Intel[®] 82371EB (PIIX4E)

Specification Update

December 1999

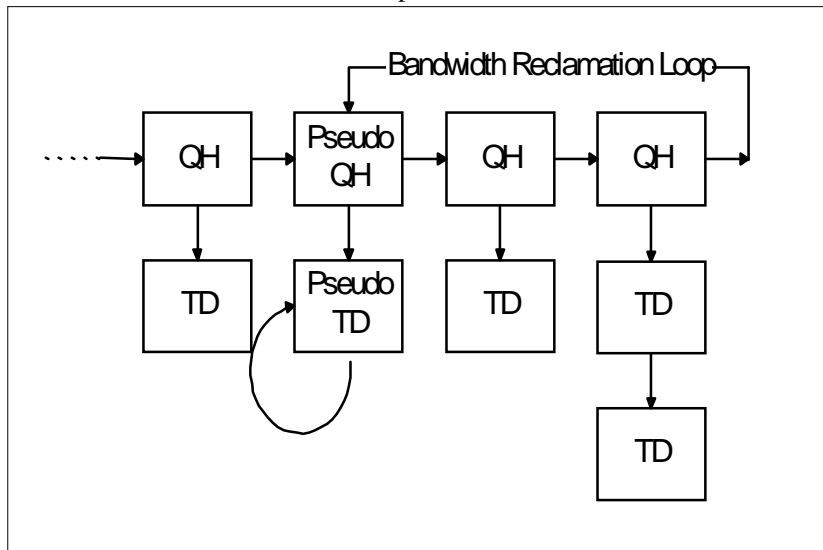
4. USB Bandwidth Reclamation Errata

Problem: This errata affects data transfers in conjunction with a UHCI driver utilizing bandwidth reclamation. In a data structure which implements bandwidth reclamation, when all the queue heads have their terminate bit set (empty QH's), the USB subsystem will be unable to read a new frame pointer and will continuously loop through the bandwidth reclamation queue heads. The effect of the errata is that the USB subsystem will continue to send out Start Of Frame packets but transfer no data. On the PCI bus the PIIX4 will continuously read the queue heads within the bandwidth reclamation loop. For additional information on PIIX4 host controller operation refer to the Universal Host Controller Interface (UHCI) Design Guide (order number 297650).

Workaround: When using bandwidth reclamation, the UHCI driver should insert a pseudo queue head with a pseudo transfer descriptor within the bandwidth reclamation loop. The PIIX4 will fetch this queue head and transfer descriptor on every frame, but will not transfer any data and will never be terminated. The following bits must be properly set to implement the workaround:

QUEUE HEAD LINK POINTER (DWORD 0: 00-03h)

The Queue Head Link Pointer (QHLP=bits [31:4]) must be set to point to the pseudo TD.

The QH/TD Select (Q=bit 1) must be set to 1 indicating it is a QH.

The Terminate bit (T=bit 0) must be set to 0 indicating that the link pointer field points to a valid TD.
